Serial No. 12-360  
LIC/CDS/R4  
Docket No. 50-305  
License No. DPR-43

**DOMINION ENERGY KEWAUNEE, INC.**  
**KEWAUNEE POWER STATION**  
**RESPONSE TO REQUEST FOR ADDITIONAL INFORMATION:**  
**LICENSE AMENDMENT REQUEST 244, PROPOSED REVISION TO**  
**RADIOLOGICAL ACCIDENT ANALYSIS AND CONTROL ROOM ENVELOPE**  
**HABITABILITY TECHNICAL SPECIFICATIONS (TAC NO. ME7110)**

**ME7110-RAII-AADB-Brown-001-2012-05-13**

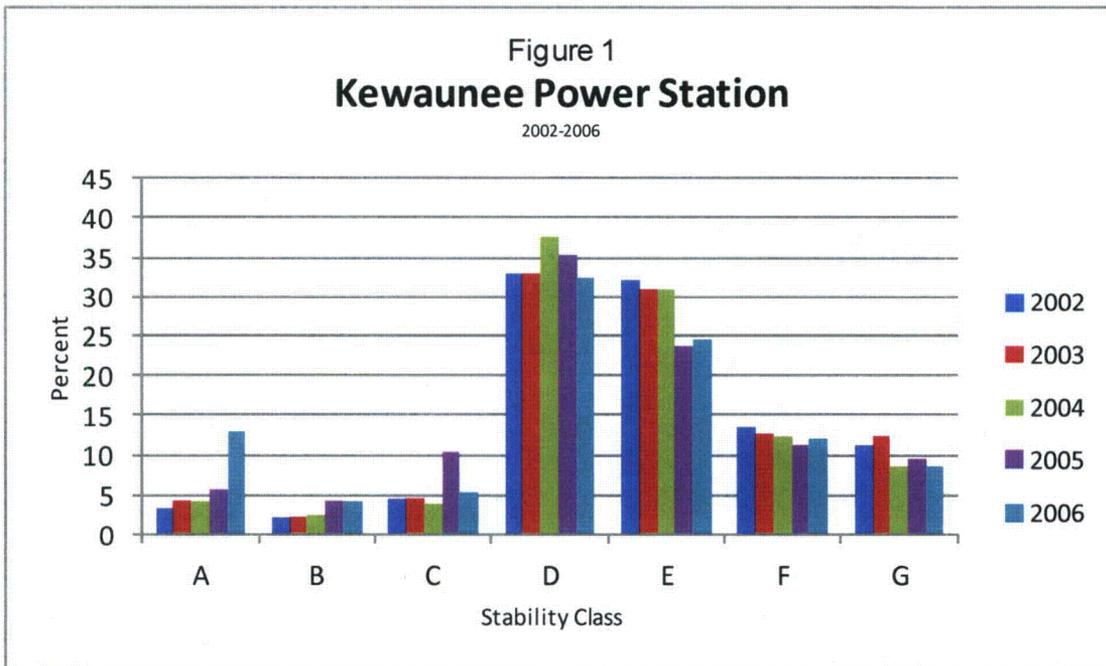
- d. Select a representative hour of data between January 2002 and December 2004 and a second hour between February 2005 and December 2006. Provide a step-by-step numerical explanation of how each of the temperature difference measurements were converted to each associated atmospheric stability category.

On 06/01/2003 at 12:00, the value of the Delta Temperature data point from the data logger was -1.280. Manually converted to a stability class using the criteria shown in the response to question 1.b, the stability was determined to be "D".

On 5/15/2005 at 12:00, the value of the Delta Temperature data point from the data logger was -2.50061. Manually converted to a stability class, the stability was determined to be "A".

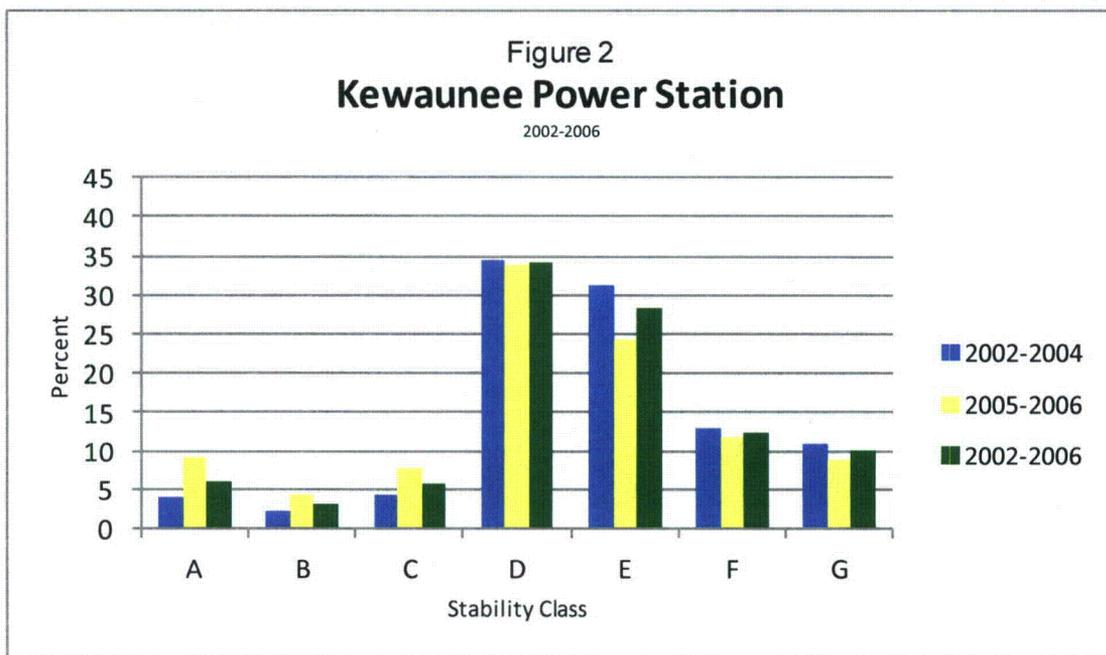
- e. In general, unstable conditions are expected to occur very infrequently at night and were reported to occur at Kewaunee only a few times at night in 2002–2004. Explain the noticeable increase in occurrence of unstable conditions at night in 2005–2006 and the increase in stability class A conditions overall from an average of approximately 1.8 percent in 2002–2004 to an average of approximately 13.8 percent in 2005–2006. In addition, discuss the occurrence of stability category A for periods longer than 12 consecutive hours in 2005–2006 (maximum length of 41 consecutive hours) as compared with the maximum length of occurrence in 2002–2004 of 10 hours.

- f. Discuss the decrease in the frequency of occurrence of stability class E from approximately 35 percent in 2002–2004 to approximately 20 percent in 2005–2006.

To compare stability class occurrence between the two subsets of data within the 2002-2006 data, Figure 2 was created to display the percent of stability occurrence for 2002-2004, 2005-2006, and the combined percentage of occurrence over 2002-2006. The stability occurrences in the new data file show no significant difference between the frequencies in each sub-set of data or to the overall frequency of the entire data file.

As discussed, the new data file that was created to correct the stability class calculation error and eliminate stability classes based on instantaneous one-second readings shows a significantly different distribution of stability occurrences. Based on the comparison shown in Figure 2, the new data file indicates normal annual variability in observed stability occurrences.

- f. As shown in Figure 2, the differences noted in the frequency of occurrence of stability class 'E' is much less in the new data file between the two sub-sets of data. From annual data displayed in Figure 1, average stability occurrence fluctuations from year to year are not uncommon. In fact, stability fluctuations for 2002-2006 compared to 2008-2011 data are similar. DEK is confident that the new data file used to perform X/Q analyses in support of LAR-244 is appropriate and provide adequate representation of local atmospheric dispersion.
